# A360 PROW ROUTE OPTIONS REVIEW

<b>Project</b>	Stonehenge
<b>Report Title</b>	A360 PRoW Options Review – Longbarrow Airman’s Corner
<b>Date</b>	01/05/2019
<b>Prepared by</b>	Momentum Transport Consultancy
<b>Prepared for</b>	English Heritage

Figure 1: Option 4 (and alternative compromise option)      Figure 2: Option 5

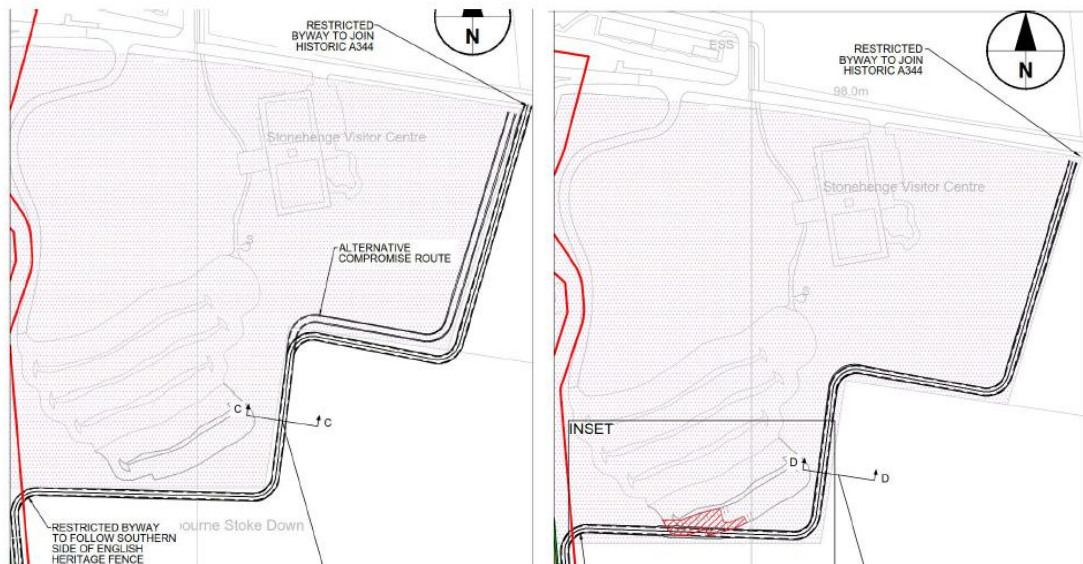
- **Option 4:** alternative to the core option that was proposed by English Heritage, with alignment around the eastern edge of the English Heritage boundary. A compromise option of this PRoW, which would see the alignment run partially outside the English Heritage boundary and partially within the boundary, is also under consideration by Highways England. Both Option 4 (supported by English Heritage) and the compromise option (not support by English Heritage) are shown in Figure 1.

- **Option 5:** alternative to the core option, with alignment routed within the English Heritage boundary, as shown in Figure 2. This option is not supported by English Heritage due to the impact of land loss.
- **Option 7:** iteration of the core option providing a 3m shared footway / cycleway with a 2m grass verge between the A360 and the proposed byway. Alignment routed to the west of the dew pond and then eastwards upon reaching the Old A344 outside of the English Heritage

- 7.31 As shown previously in Figure 1, the Option B alignment would provide a connection for NMUs from the A360 PRoW to the old A344, to the east of the Visitor Centre. Design iteration Option 4 of Option B would involve four turns for users and the alignment would be outside of the English Heritage site boundary. A compromise option was suggested by Highways England whereby, on the third turn, the alignment would continue to follow the English Heritage boundary, but would run within the boundary, with a further turn to connect to the old A344. Design iteration Option 5 would follow a similar alignment to design iteration Option 4 and the compromise option, but would be entirely within English Heritage land. English Heritage do not support design iteration Option 5 or the compromise option.

- 7.50 As shown previously in Figure 1, the PRoW in this option would terminate where the three potential routes meet. The remainder of the route for NMUs would be via a smaller footpath only suitable for pedestrians and dismounted cyclists. Access to the footpath would be via a gated access at that point, which would be locked outside of visitor hours. There would be no provision for equestrian carriages beyond that point.
- 7.51 This route would not involve any highway crossings for NMUs, thereby reducing potential NMU vehicle conflict points. This would benefit all users of the PRoW.

Figure 8 Potential loss of car parking in Option B (Design Iteration Option 5, restricted byway realigned inside of EH boundary)

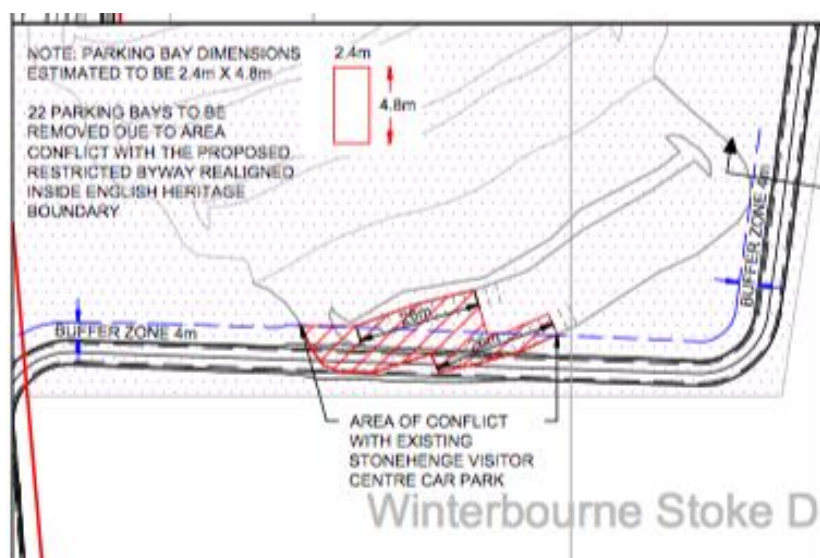
- 7.38 Option B design iteration Option 5 (restricted byway realigned inside of EH boundary) would result in the loss of 22 parking bays, as shown in Figure 8. Further, and as inferred by the latest Report of Travel Surveys (Dec 2018), the peak number of vehicles parked in a single hour across in the visitor car park between 22<sup>nd</sup> August 2018 and 4<sup>th</sup> September 2018 was recorded as 722 vehicles in the peak hour (25<sup>th</sup> August 2018 between 13:00 and 14:00). With an average dwell time of approximately 2 hours recorded for visitors in these surveys, it is reasonable to expect repeated usage of these spaces (up to four times in line with the Visitor Centre summer opening hours (09:30 – 17:00)), resulting in a possible capacity loss of 88 spaces for cars during peak visitation periods. This design iteration is therefore unacceptable to English Heritage due to the significant negative financial and operational impacts it represents.

- 7.44 Option B design iteration Option 4 would not result in any loss of existing car parking supply for English Heritage, nor would the compromise option suggested by Highways England.
- 7.45 Option B design iteration Option 5 (restricted byway realigned inside of EH boundary) would result in the loss of approximately 22 parking bays, as shown previously in Figure 6. Further, and as detailed above, this could equate to the loss of up to 88 spaces over the course of the day during busy visitation periods due to repeated usage of these spaces by different visitors. This design iteration is therefore unacceptable to English Heritage due to the significant negative financial and operational impacts it represents.
